## **NOTICE OF PUBLIC HEARING** **Minor Variance**

**APPLICATION NO.:** AN/A-21:199

**SUBJECT PROPERTY:** Municipal address **2004 Glancaster Rd., Ancaster**

**PROPOSAL:** To permit the construction of a 4,253 square metre manufacturing building to be used for the manufacturing of wire baskets and moss products upon demolition of an existing manufacturing building, notwithstanding,

**SITE PLAN**

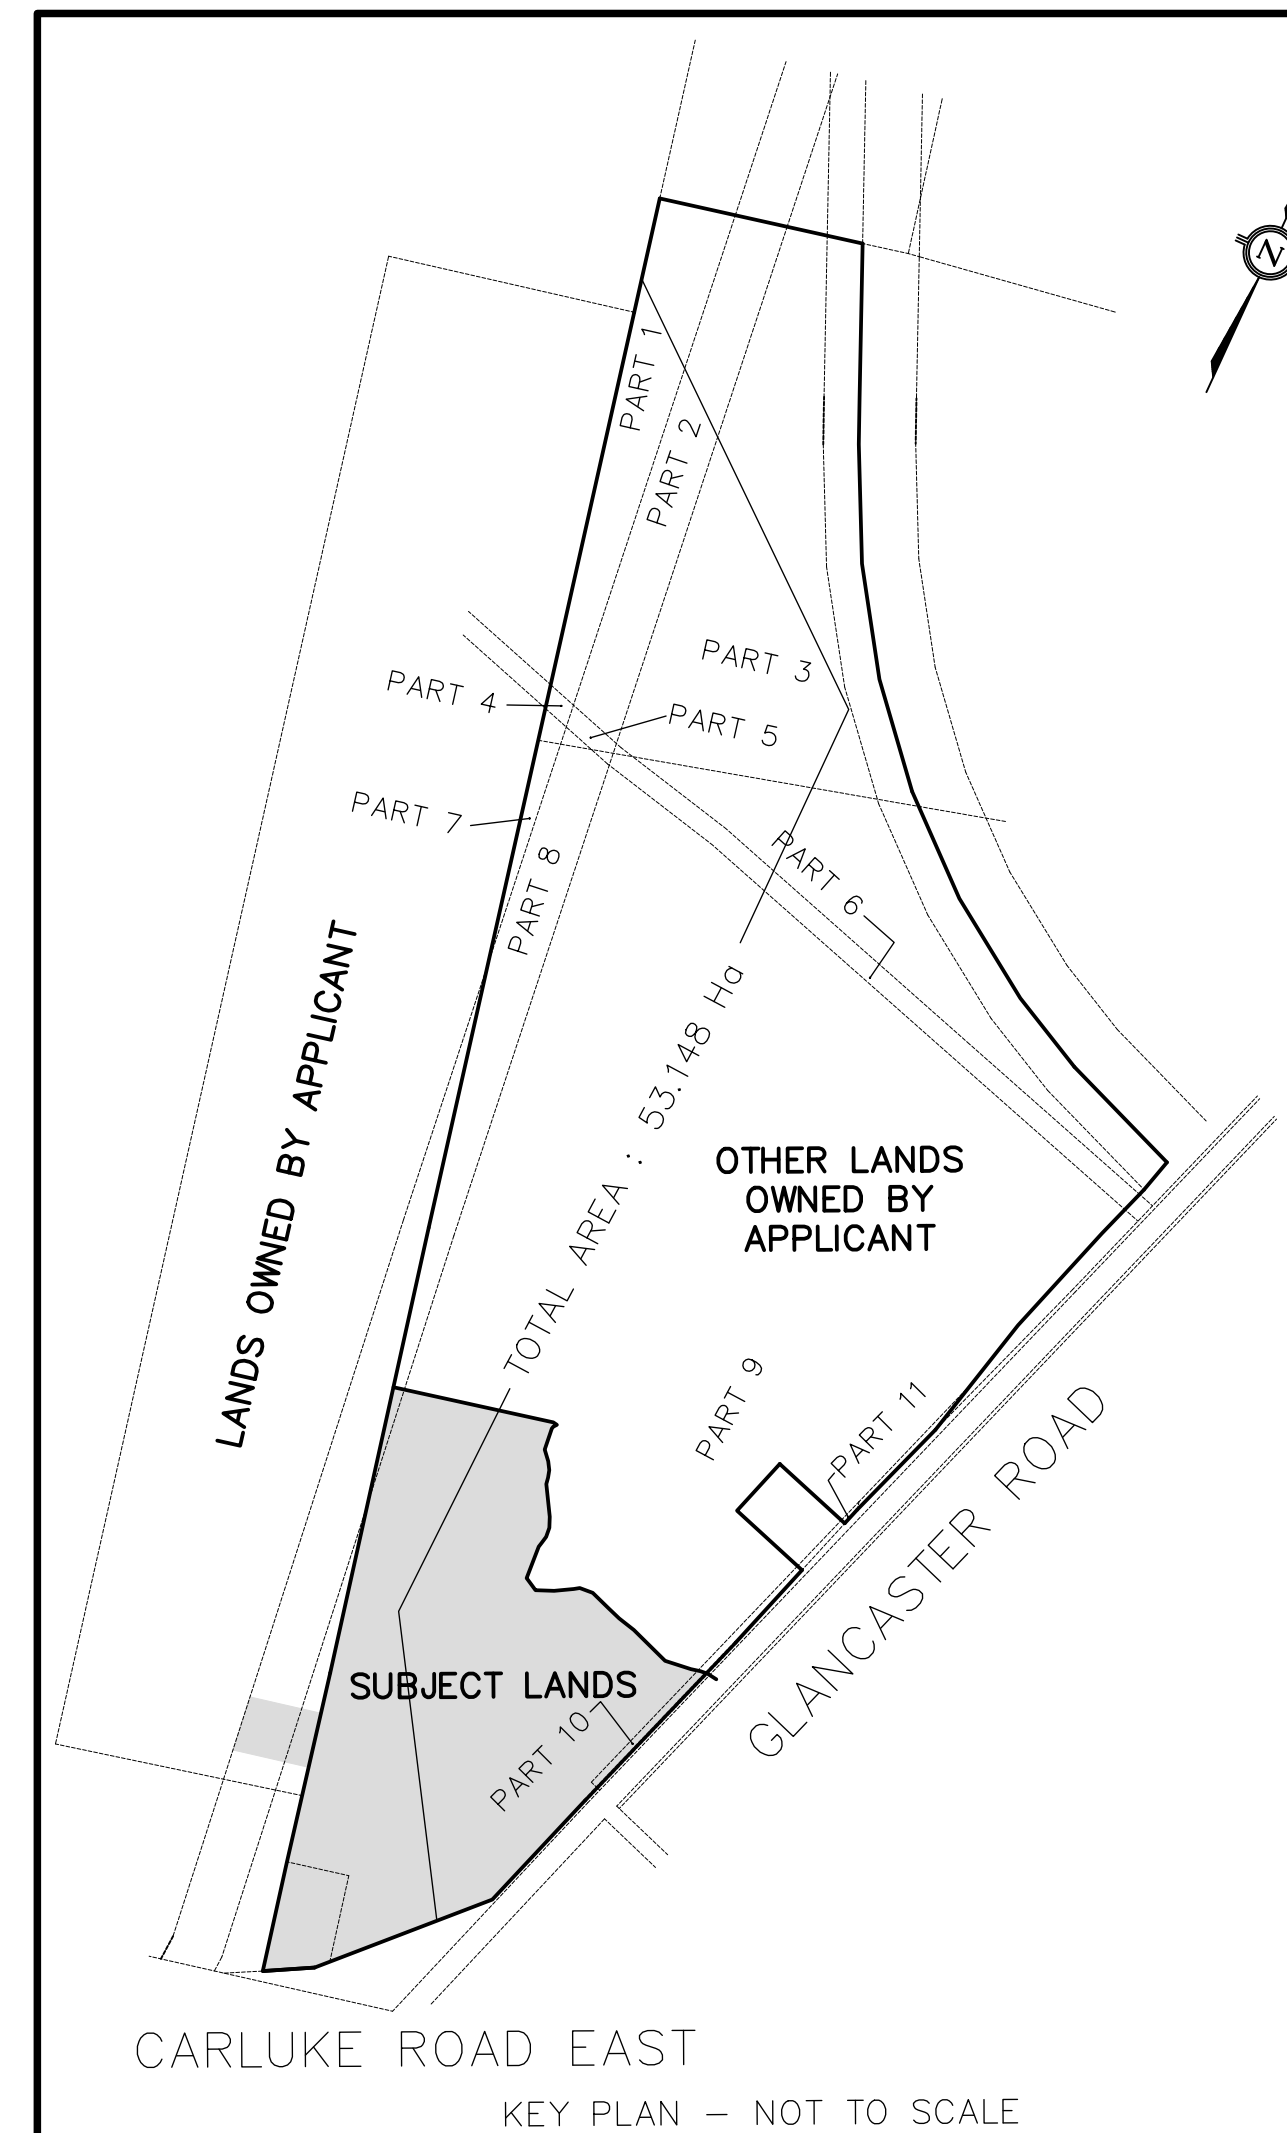
2. A planting strip with a minimum width of 3.0 metres is required to be provided abutting the street, except for points of ingress and egress, however, a 3.0 metre wide landscaped area is noted to be provided. A further variance will be required if a 3.0 metres wide planting strip is not provided.

3. A further variance will be required if the access driveway is not constructed of asphalt, concrete or other hard surfaced material for a minimum of 10 metres extending from the street line.

4. A further variance will be required of a visual barrier provided in accordance with Section 4.19 of the Zoning By-law is not provided between the proposed loading facilities and the street line.
